**DOCKET ITEM #8**  
**Master Plan Amendment #2020-00009**  
**Text Amendment #2021-00002**  
**Rezoning #2021-00003**  
**CDD Concept Plan #2020-00007**  
**Landmark Neighborhood – 5701, 5701B, 5801, 5815, 5901 Duke Street**

Application	General Data	
<b>Project Name:</b> Landmark Neighborhood CDD	PC Hearing	June 24, 2021
	CC Hearing	July 6, 2021
	If approved, CDD Expiration	July 6, 2051 (30 years)
	Plan Acreage	2,241,885 sq. ft. (51.5 acres)
<b>Address:</b> 5701, 5701B, 5801, 5815, 5901 Duke Street	Existing Zones	CR/Commercial Regional CRMU-M/Commercial Residential Mixed Use (Medium)
	Proposed Zone	CDD #29 / Coordinated Development District #29
	Proposed Uses	Hospital, medical office, office, multi- family, townhouse, retail, restaurant
	Total Floor Area – <i>Max Residential</i>	5,565,000 sq. ft.
<b>Applicant:</b> Landmark Land Holdings, LLC c/o Foulger-Pratt, 12435 Park Potomac Ave, Potomac, MD 20854	Small Area Plan:	Landmark Van Dorn Corridor Plan

**Purpose of Application**

Figure 1: Framework Plan and Complete Streets Typology

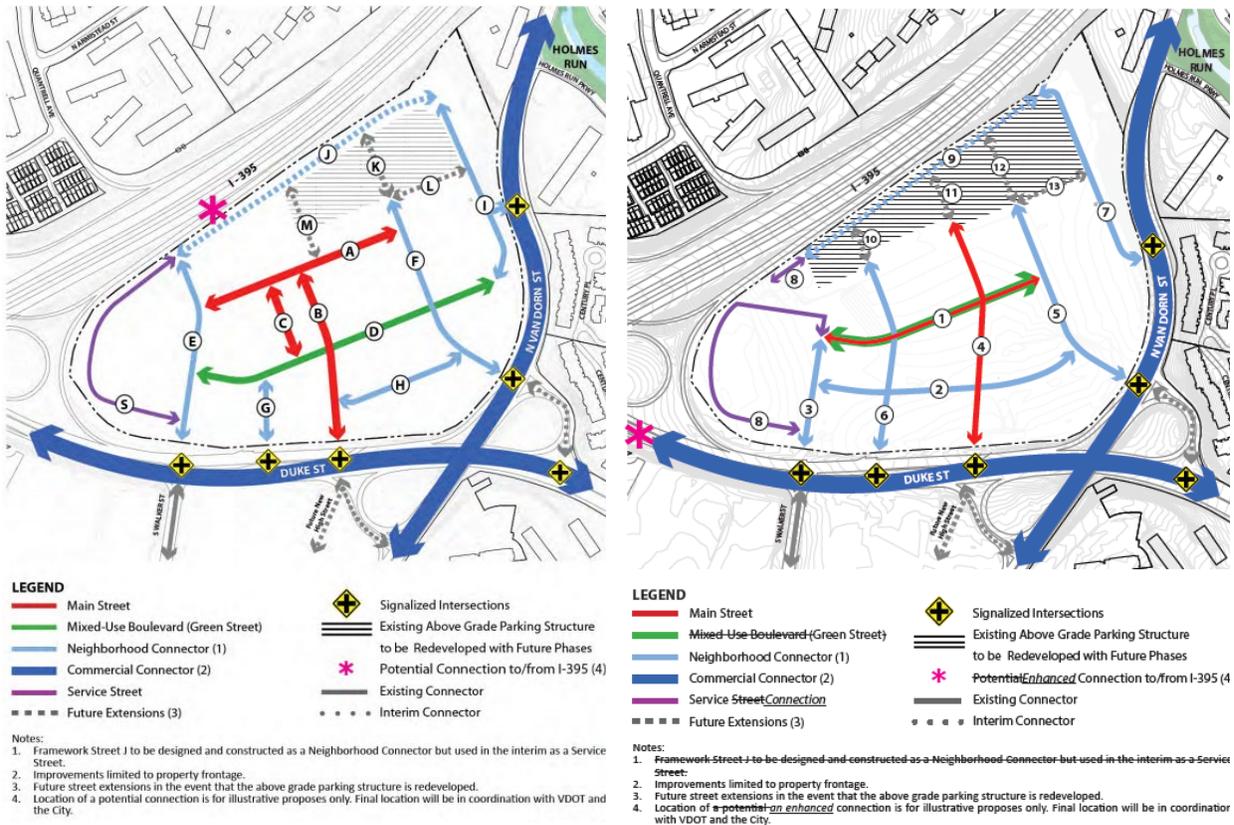
The street framework is one of the fundamental elements of the Corridor Plan that sets the stage for the future urban environment and how people use and access the site. The proposed revisions are depicted below (Figure 1).

in Figure 1, the applicant proposes Street 2 to function as a Neighborhood Connector, as opposed to a Mixed-Use Boulevard (Street D), as prescribed by the Plan.

Figure 2: Transit Hub

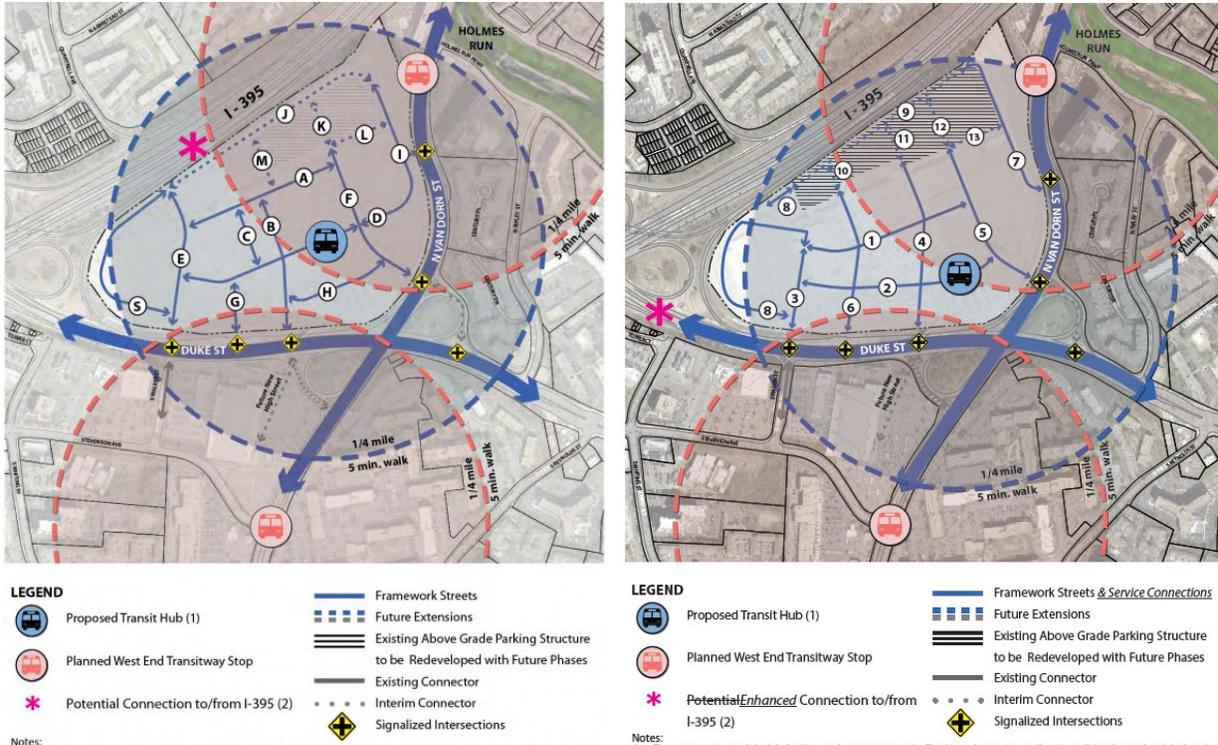
The applicant proposes to slightly modify the location of the transit hub to the south on the site due to the reconfigured street network, as shown in Figure 2. Staff supports the proposed location of the transit hub between Streets 4 and 5 on Street 2 as it is shown generally in the location intended by the Corridor Plan to support greater access and use of transit as an efficient and convenient transportation option. The proposed street framework eliminates the needs for Street H in the Plan, allowing for a more prominent location of the hub one block closer to the entrance of the site.

2019 Landmark Van Dorn Corridor Plan  
 Figure 4: Pedestrian and Bicycle Facilities

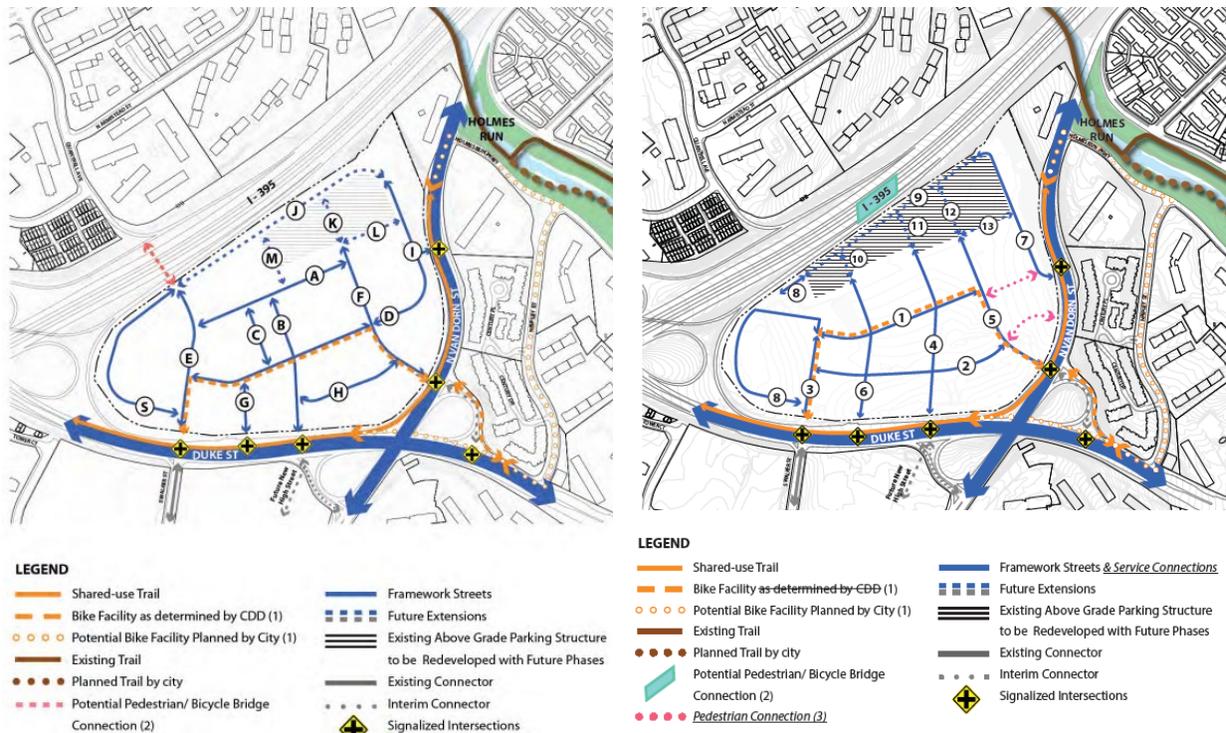
The applicant proposes to modify the plan’s pedestrian and bicycle facilities network to accommodate an east/west connection along Street 1 (Street A in the Corridor Plan) instead of Street 2 (Street D in the Corridor Plan), to include pedestrian connections between Streets 5 and 7, and to update the symbol for the potential pedestrian/bicycle bridge over I-395, as depicted in Figure 4, below.

As seen in Figure 4, the proposed amendment is consistent with the intent of the Corridor Plan, which is to ensure appropriate non-automotive ingress and egress and internal bicycle connections through the site. Consistent with the Plan, the east/west bicycle connection facilitates safe cycling to the retail core and Central Plaza from two north/south connections along Streets 3 and 5.

2019 Landmark Van Dorn Corridor Plan MPA Request  
 Figure 7: Building Heights

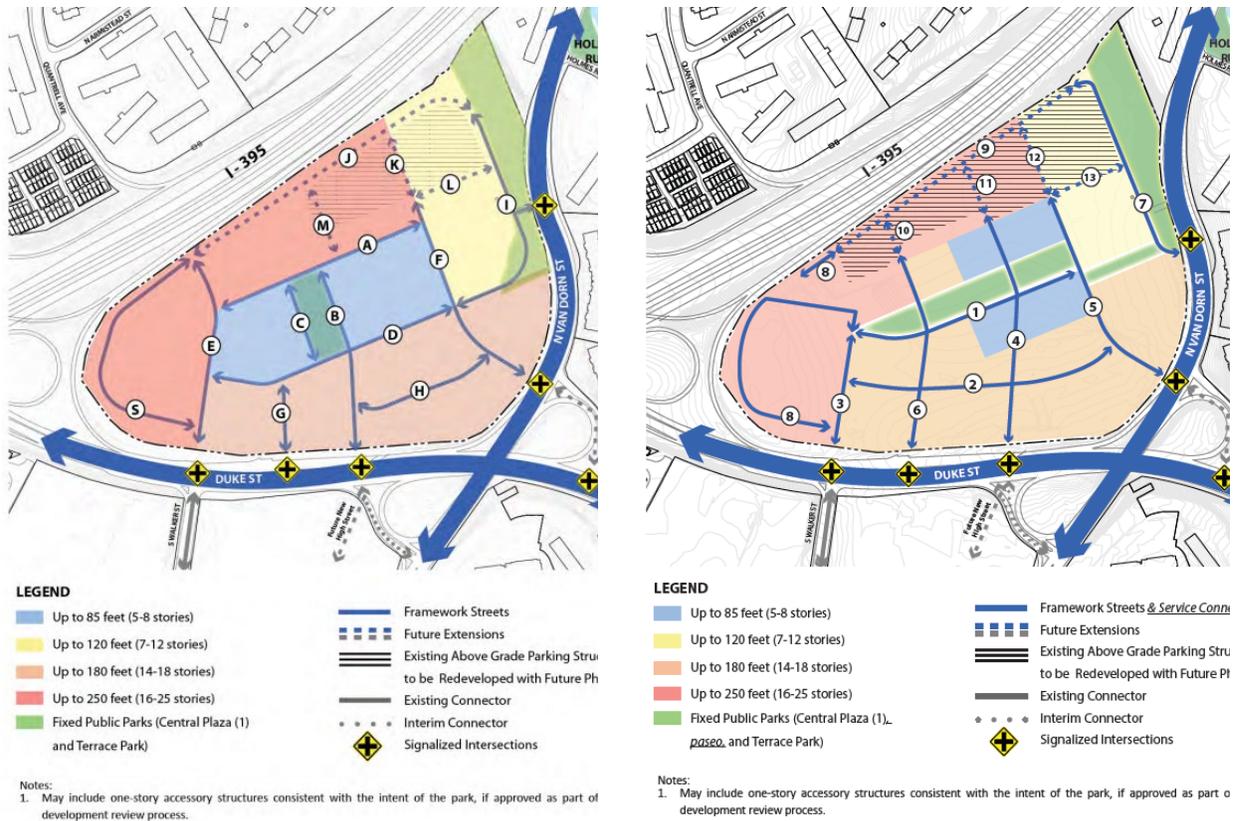
The applicant proposes to modify the Corridor Plan's building heights, as depicted below (Figure 7).

Figure 8: Building Streetwall, Gateway and Placemaking Opportunities

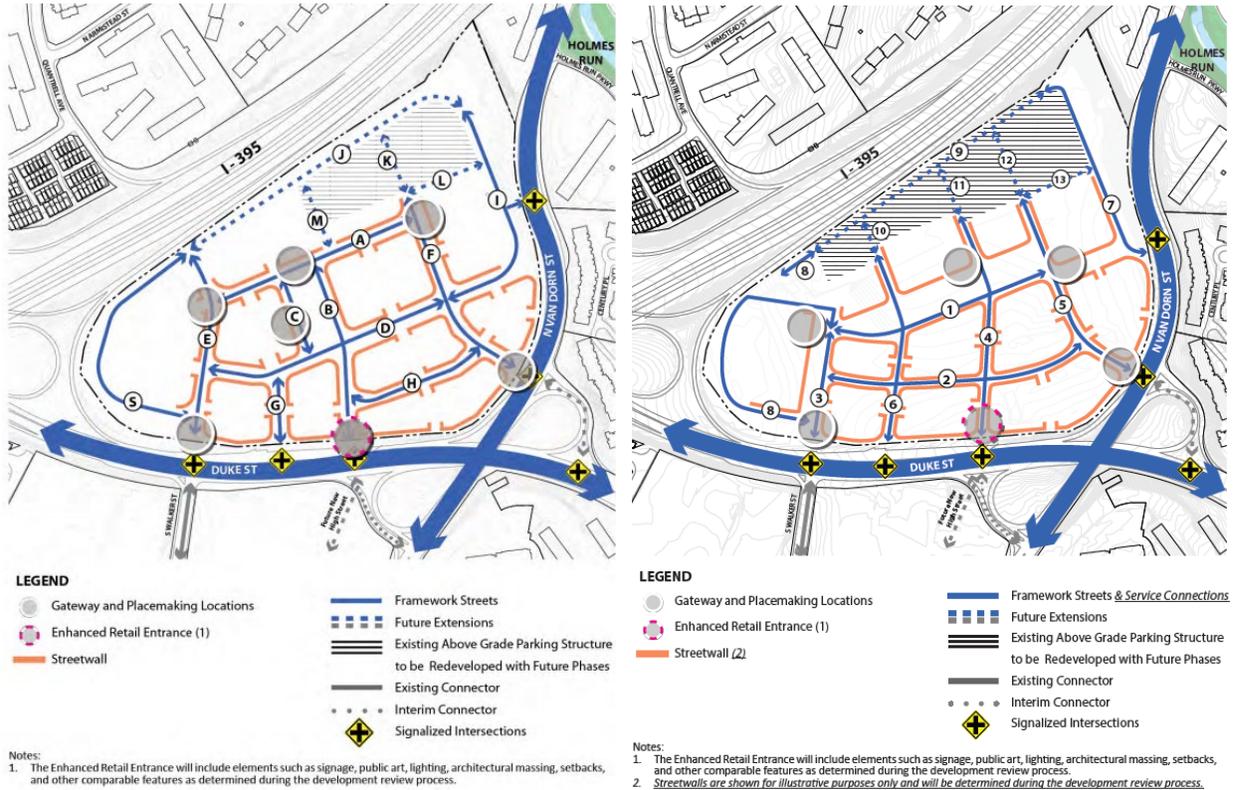
The applicant proposes to modify the Corridor Plan’s streetwall, gateway and placemaking locations to reflect the proposed street network and revised Central Plaza location, as illustrated below (Figure 8).

Figure 1: Plan Area-wide Connectivity

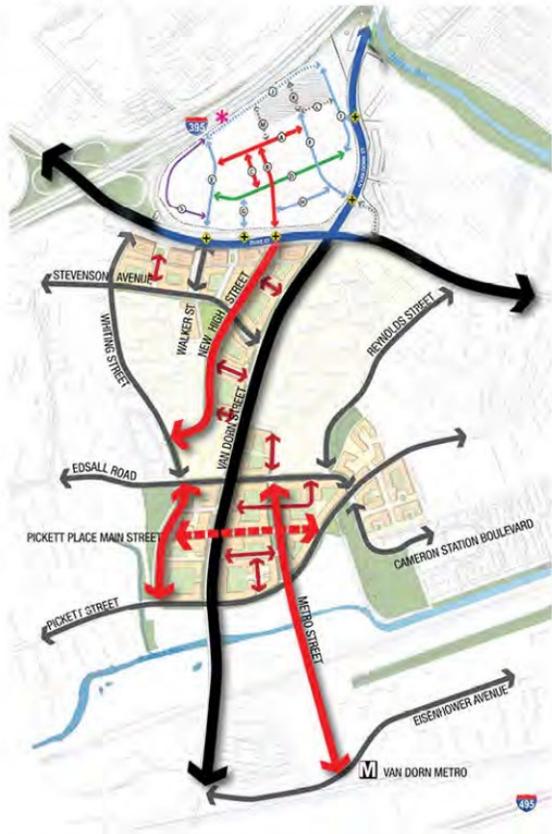
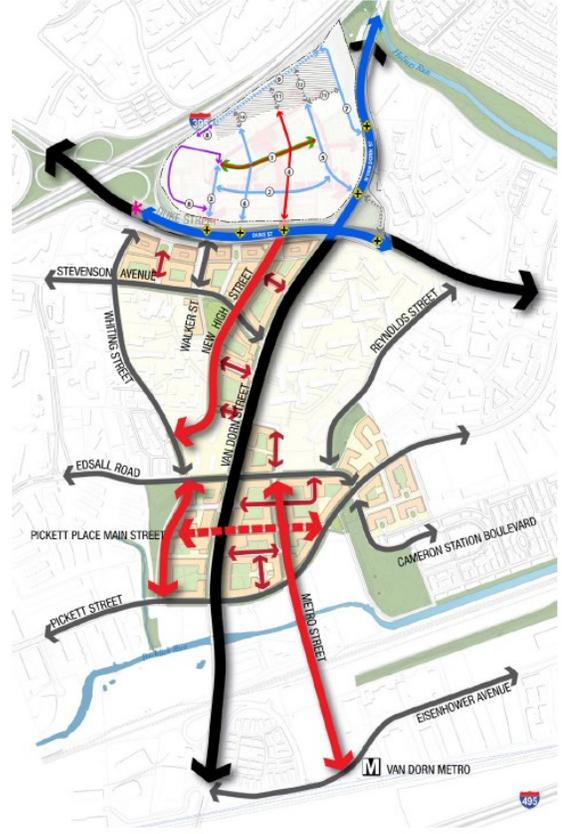
The Applicant requests that this Figure be updated where appropriate to reflect the various amendments requested in further detail below. In particular, street typology, street names, street locations, and the retention of the entire existing parking structure discussed in item 2 below should be reflected in Figure 1.

**Figure 2: Framework Plan and Complete Street Typology**

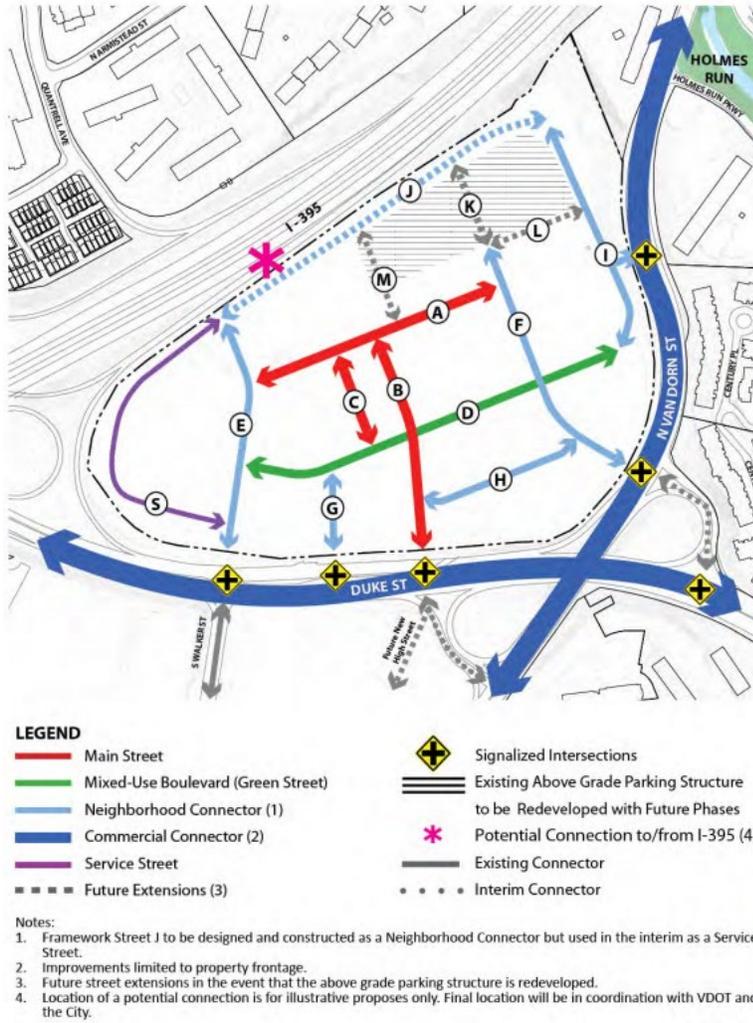
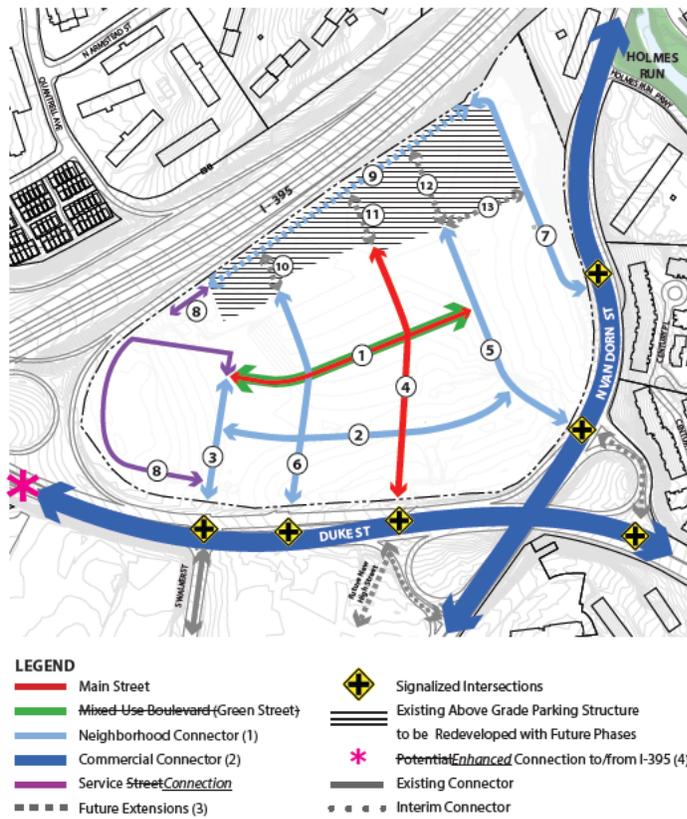
The Applicant also requests that the labeling on the legend of Figure 2 be modified to remove “Mixed-Use Boulevard” but retain the “Green Street” label. The legend should also be modified to include a “Service Connection” designation for Road 8, consistent with the CDD Plan. While this Service Connection will provide access for ambulances, fire trucks, and loading/unloading, given the grading of the site, this connection is not a through connection and will not be used by the general public.

These changes are not inherently confined to Figure 2, and where appropriate, these changes should be carried throughout any and all maps included as part of the SAP, including the other Figures referenced below.

Figure 9: Transit Hub

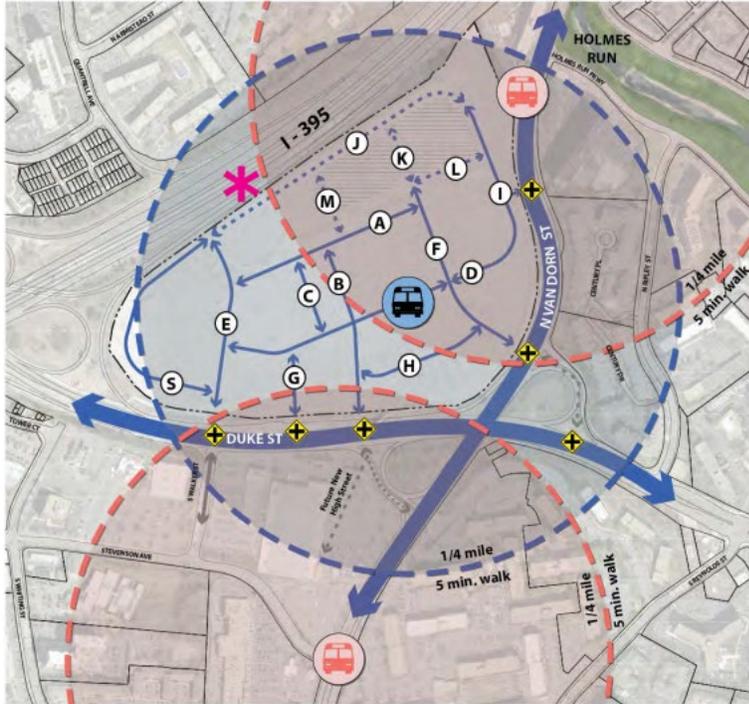
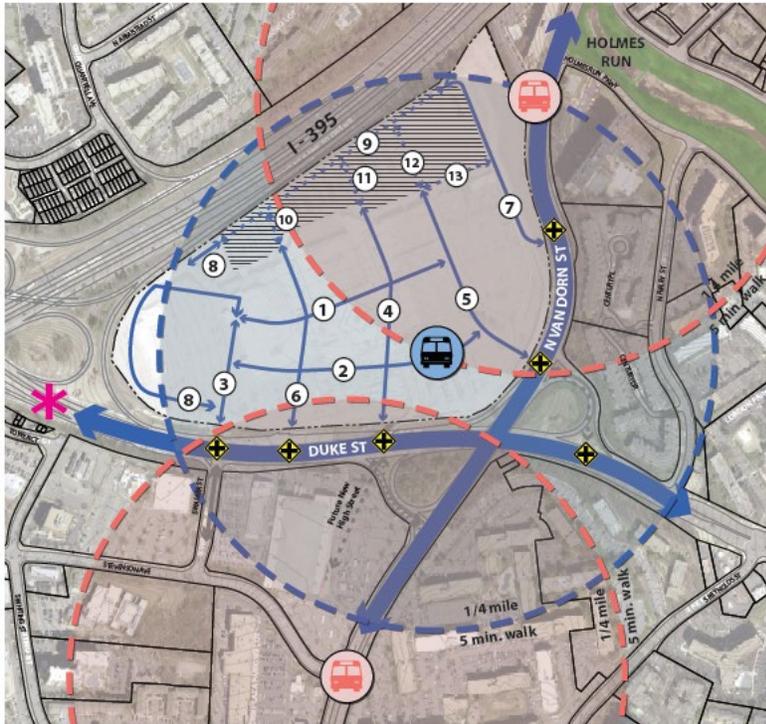
The Applicant requests an amendment of Figure 9 to relocate the proposed transit hub to its location along Road 2, between Roads 4 and 5.

Figure 10: Pedestrian and Bicycle Facilities

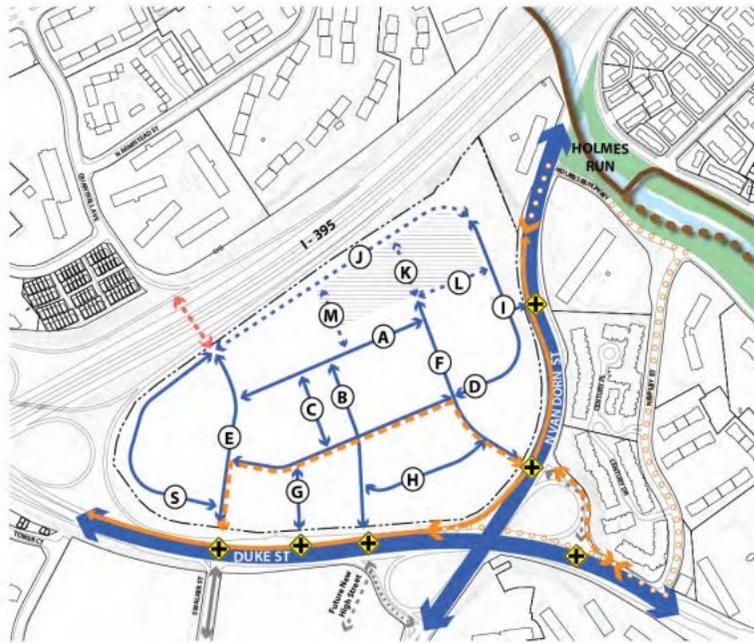
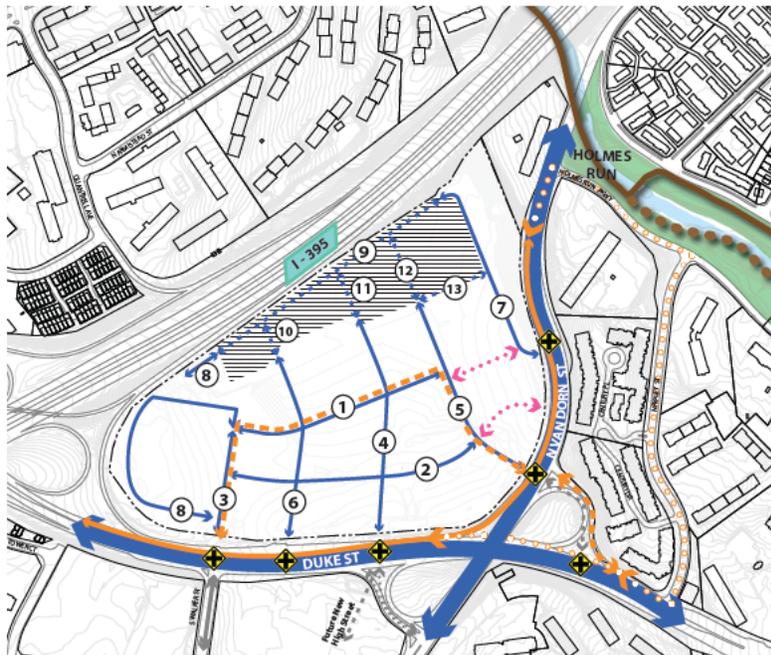
The Applicant requests an amendment to the location of bicycle facilities consistent with Sheet 07 of the CDD plan. These changes are necessary to realign the bicycle facilities with the revised road network, and do not represent any changes to functionality. The Applicant also requests an amendment to identify the off-site bike facility south of N. Van Dorn Street as “Potential Bike Facility Planned by City.”
